UNITED STATES PATENT AND TRADEMARK OFFICE

APPLICATION NO.	FILING DATE	FIRST NAMED INVENTOR	ATTORNEY DOCKET NO.	CONFIRMATION N
10/697,815	10/29/2003	John Trezza	4024-4043	9556
27123	7590	08/10/2005	EXAMINER	
MORGAN & FINNEGAN, L.L.P. 3 WORLD FINANCIAL CENTER NEW YORK, NY 10281-2101			NGUYEN, PHILLIP	
			ART UNIT	PAPER NUMBER
			2828

Office Action Summary

DETAILED ACTION

Fig. 3

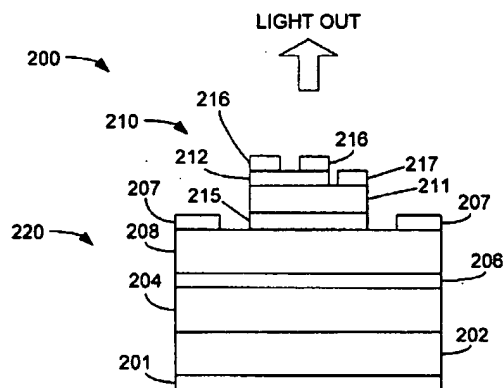
With respect to claim 1, Aronson discloses in Fig. 3 a laser-based device comprising a VCSEL-type laser having an active side 220 and a passive side 210 opposite the active side; and a photodetector 210 unit on the passive side, the photodetector unit comprising an absorbing region located so as to receive leakage photons exiting the laser through the passive side, and a

"Schottkey" contact 212 having a first portion abutting the absorbing region (in the photodetector section) and through which a current, caused by absorption of the leakage photons in the absorbing, can be measured.

With respect to claims 2 and 4, Aronson discloses a substrate 202 abutting the active side.

With respect to claim 3, Aronson discloses an access way over at least a portion of the active side (window from 215) so that, when the laser emits light through the active side, the emission will pass through the access way.

With respect to claims 10-11, Aronson discloses in active side comprising an active side mirror 104/204/304 for being p-type. However, Aronson also teaches p-type could be replaced with n-type (col. 11, lines 7-11) and the mirror consists AlGaAs.

With respect to claims 12 and 13, Aronson discloses the photodetector having absorbing region 215 being semiconductor material which is also considered as semi-insulating material comprising GaAs (AlGaAs).
